RE: OSDS Plan
13375 Forsythe Road

RE: OSDS Plan
13375 Forsythe Road
Hofmeister Property, Lot 2

SEPTIC SYSTEM
 INSTALLATION SITE PLAN

13375 FORSYTHE ROAD
 Hofmeister Property
 LOT 2
 ZONED RC-DEO

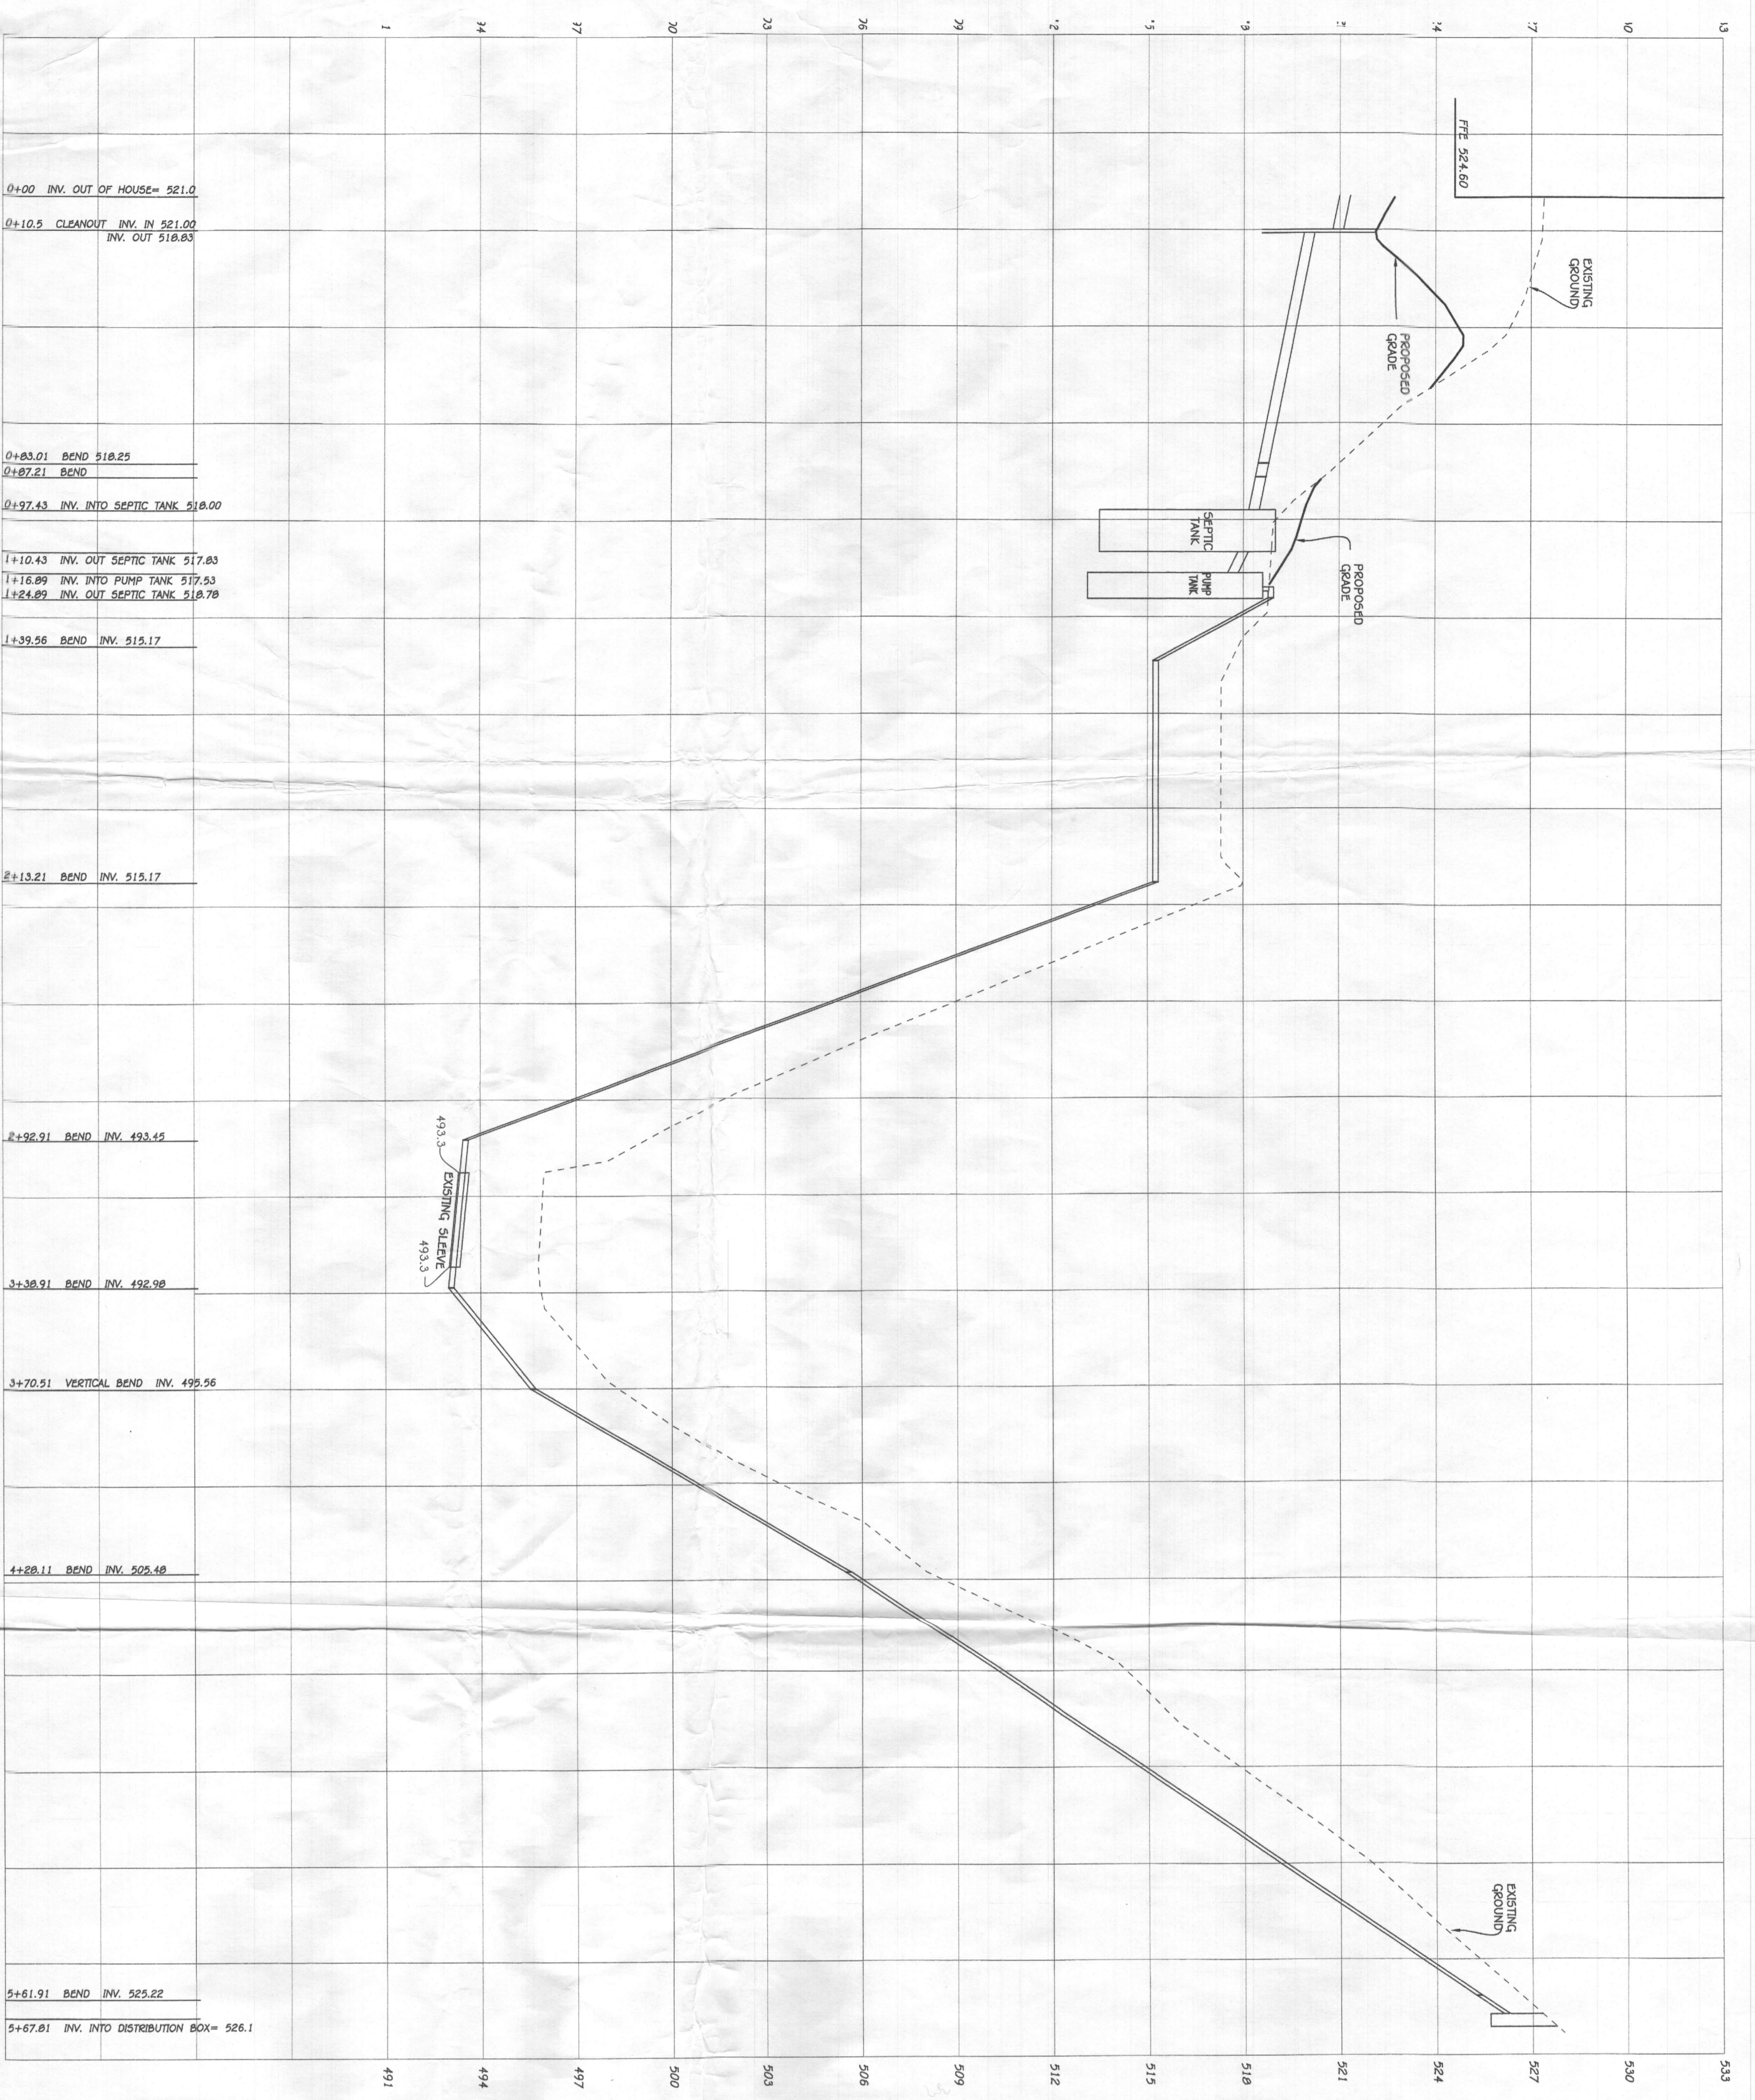
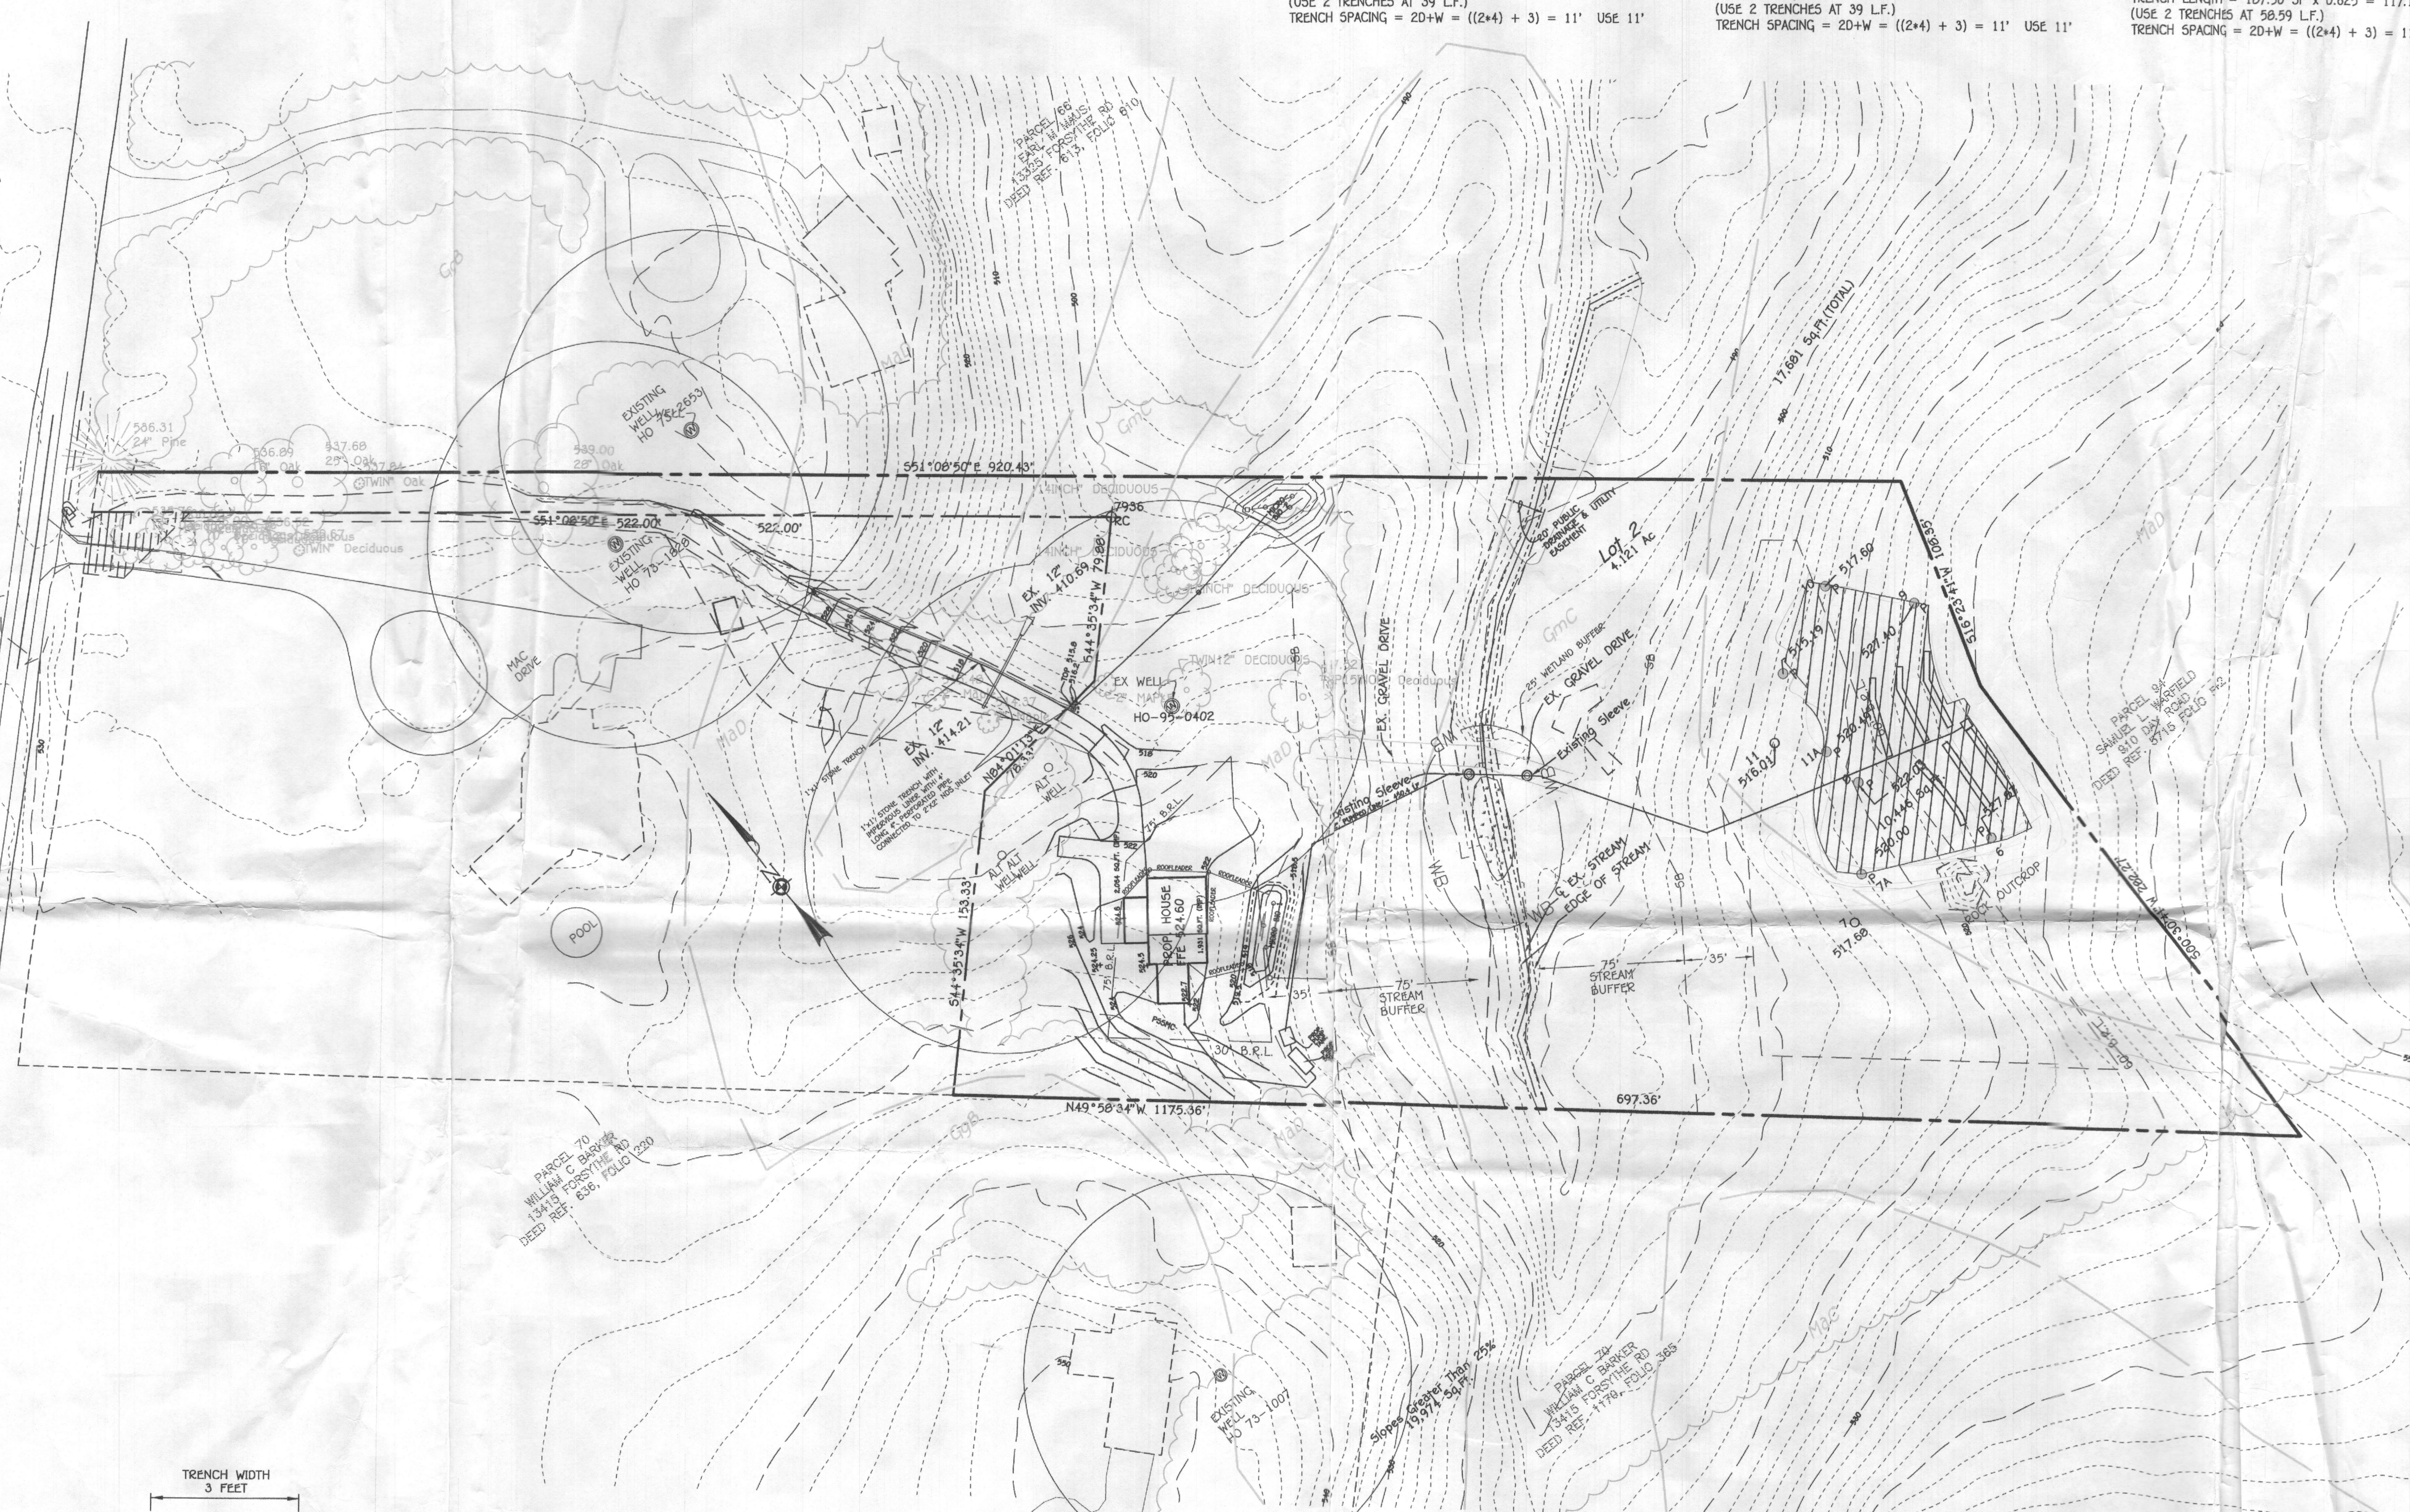
In addition to the specs on the storm water management device near the tanks, we need to see the tanks more on contour due to the steep slopes (per my supervisor) while making sure they are kept 25 feet from the discharge pipe. Also, please show two alternate well sites while maintaining 50 feet from the discharge pipe.

We don't usually like the force main running up through the SDA but we will accept it. It would be nice to see the trenches lengthened a little bit but it isn't a requirement.

- 1.) As previously stated in first memo, match the shape of the SDA on plan with perc cert plan (see attachment) or revise perc cert plan. (Top of SDA does not match.)
- 2.) Tanks must be located 25 feet from steep slopes.
- 3.) The pump tank appears to be shown before the septic tank on plan.
- 4.) Provide cut sheet with details on the storm water management device near tanks (Classification, lined/not lined etc.). Please label on plan.
- 5.) Add a note; the septic line to be installed in the existing sleeve beneath stream marked by green metal stakes.
- 6.) Volume of force main (450LF x 17.4 gallons/100 feet = 78.3) gallons is slightly more than 1/6th the design flow (75 gallons). Use 81gallon dose as stated.

- 1.) Match shape of SDA on plan with perc cert plan or revise perc cert plan.
- 2.) Add test hole P-7 to plan.
- 3.) Label object next to test hole P-6.
- 4.) Label/show sleeve extending on both sides of the stream buffer on 1st page and label diameter and depth of pipe. Also, label circles on plan next to sleeve.
- 5.) Add note to indicate the septic line will be installed by directionally boring underneath stream or through MDE permitting process.
- 6.) Raise trench inverts to a minimum depth of 18 inches in keeping with proper system design.
- 7.) Label septic tank/pump tank on 2nd page. The septic tank must show two compartments.

It looks like one end of the sleeve is in the stream. Please clarify stream edge on plan because there are so many lines. It's not really clear. Add note that the ~~well~~ ^{septic} line will be installed in the existing sleeve. Add labels to sleeve turn ups on plan.

Attached, please find a copy of the perc cert plan along with additional comments to the OSDS plan for 13375 Forsythe Road. Are the elevations in the septic profile for the sleeve shown accurately? Another word, have the sleeve elevations been field verified?

1. P-7 has been added.
2. Object has been labeled as a rock outcrop.
3. For clarity, we have only shown the stream centerline instead of top of slope lines shown on the previous plan. The circles mark the start and end of the existing sleeve.
4. Since sleeve exists, the directional bore is not required.
5. Trench has been shown with an invert of 1.6'.
6. Tanks have been labeled. Detail has been revised.
